Masanobu Miyahara International Linear Collider (ILC) -CFS

# **CFS Work for Change Requests**

### **Extension of the ML Tunnel**

ILC-CR-0004

### **ML Tunnel Length: TDR Baseline**

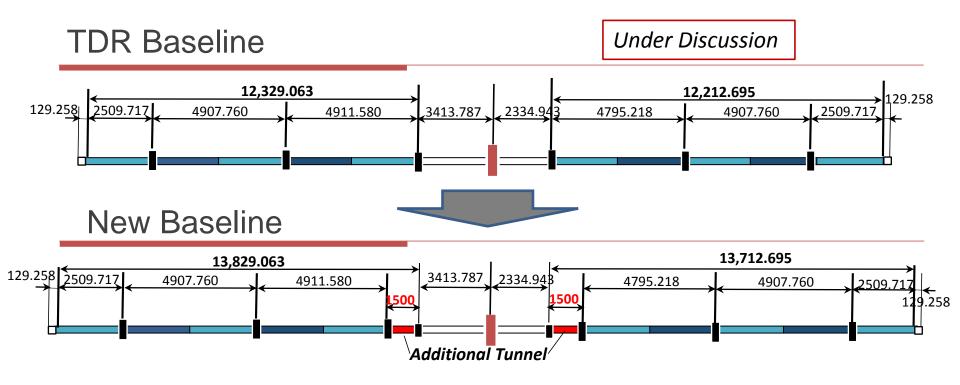
Change Request proposed

- 1. Detector Hall with Vertical Shaft access (CR-0003)
- 2. Extension of the ML-tunnel length (CR-0004)

- 1. ML Shield-wall thickness
- 2. BDS Tunnel configuration
- 3. Cryogenics Layout
